MPLAB® Debugger Adapter Board AVR Interface Modification

Symptom: Programming and debugging of AVR microcontroller devices that use the PDI, TPI and DebugWire Interface results in a “Connection Failed” message. Assembly #12-10776-R1 (PCB marking REV 4) is mis-wired for AVR interfaces that require the use of the AUX pin.

Figure 1

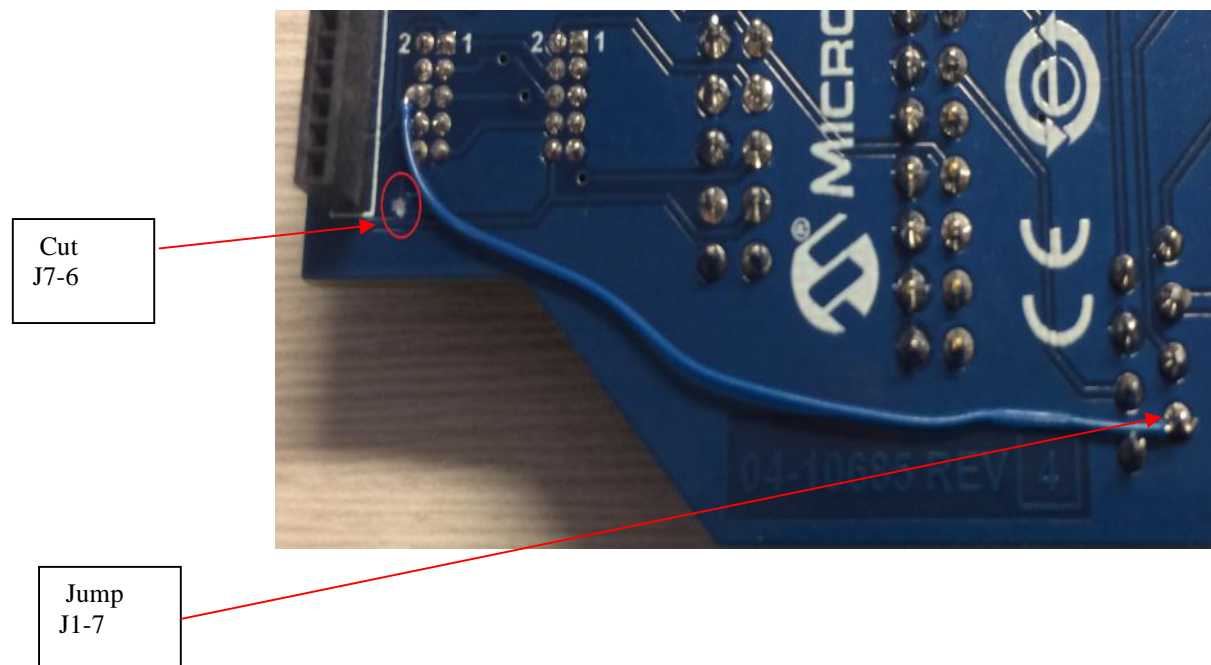
AVR microcontroller have fragmented programming and debugging interfaces which make use of different pins for different functionality depending on chosen interface. The pinout for RESET on the adapter when using AVR devices can vary from a true RESET, a clock source, or a bidirectional data line. The typical ICSP line NMCLR does not have bidirectional data line capability and is not applicable to serve as a multi-function signal for all these interfaces.

Solution: For AVR interfaces, the AUX line should be used rather than NMCLR for AVR RESET, DATA IO, and Clock pin functionality. This requires a cut and a jump on the J7-6 connector labeled “AVR JTAG”. The jump connects J7-6 pin to J1-7.
